Subject: Kinch Minor Subdivision (MS-204)

**Development
Application
Permit
Review**

Kinch Minor Subdivision

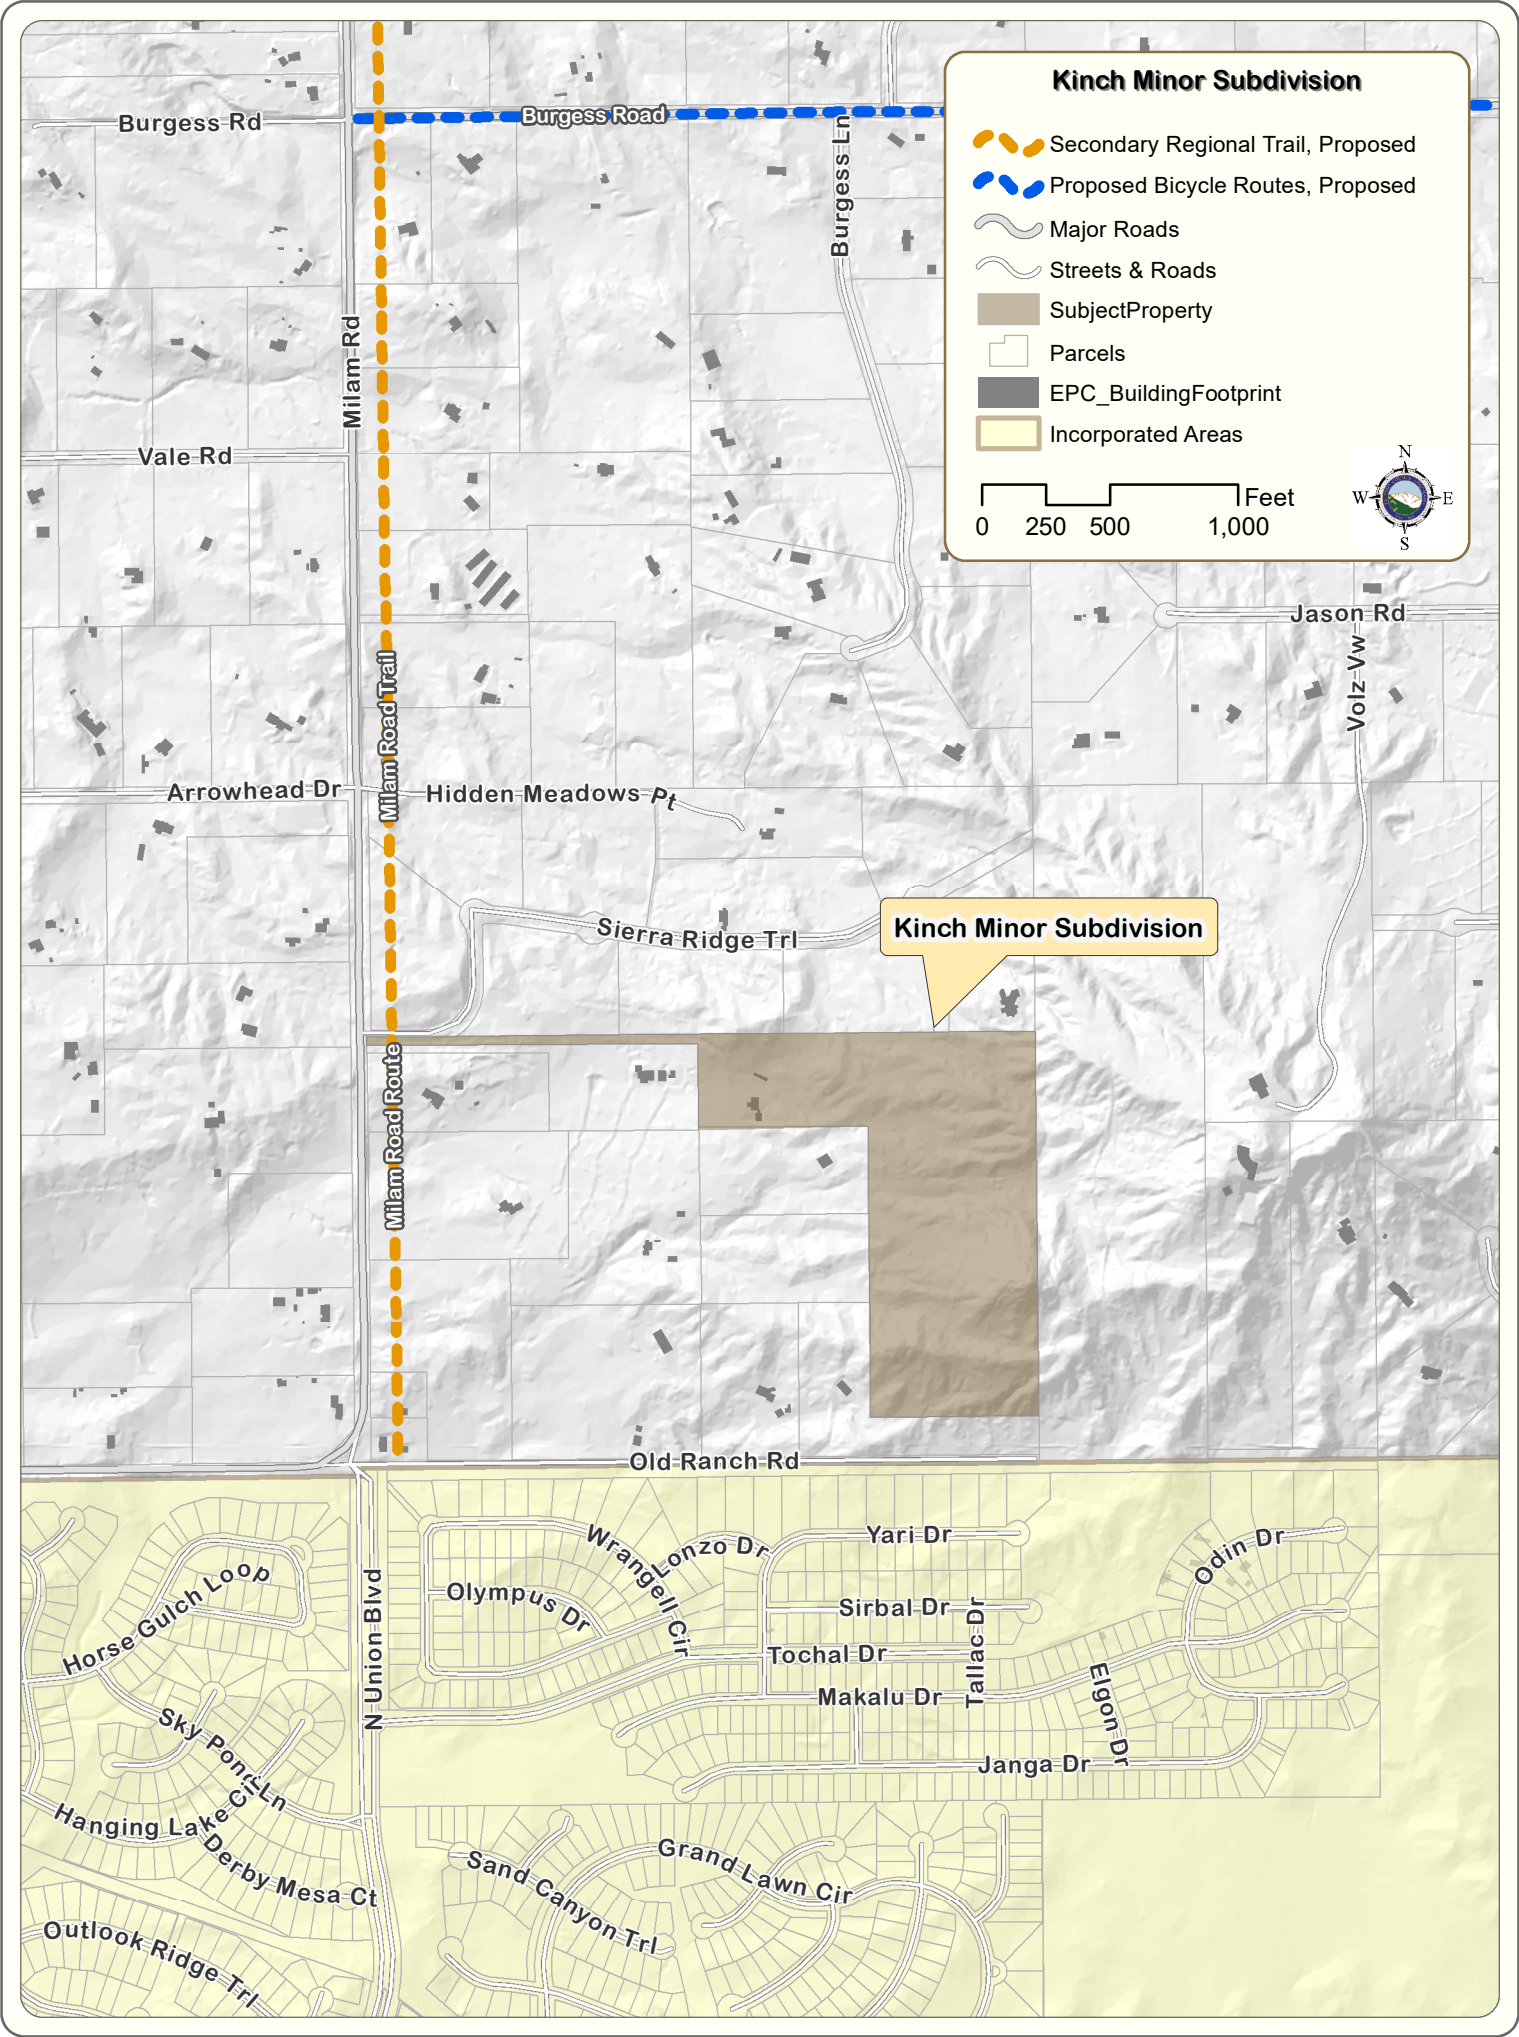
The 2013 El Paso County Parks Master Plan shows the Proposed Milam Road Secondary Regional Trail running north and south along the east side of Milam Road. The proposed trail intersects the Kinch Minor Subdivision for 30' along the extreme west side of the parcel.

County Parks requests trail easements where development projects impact proposed County trails. As it pertains to this application, the County requests that the landowner provide a 25-foot-wide public trail easement along the western boundary immediately adjacent to the public right-of-way for Milam Road that allows for the construction and maintenance by El Paso County of the Milam Road Secondary Regional Trail, and this easement shall be shown and dedicated to El Paso County on the Final Plat.

Recommend that the Planning Commission and the Board of County Commissioners include the following conditions when considering and/or approving the Kinch Minor Subdivision: (1): Designate and provide to El Paso County a 25-foot-wide trail easement along the western boundary immediately adjacent to the public right-of-way for Milam Road that allows for public access, as well as construction and maintenance by El Paso County of the Milam Road Secondary Regional Trail. (2) Require fees in lieu of land dedication for regional park purposes in the amount of \$1,840.
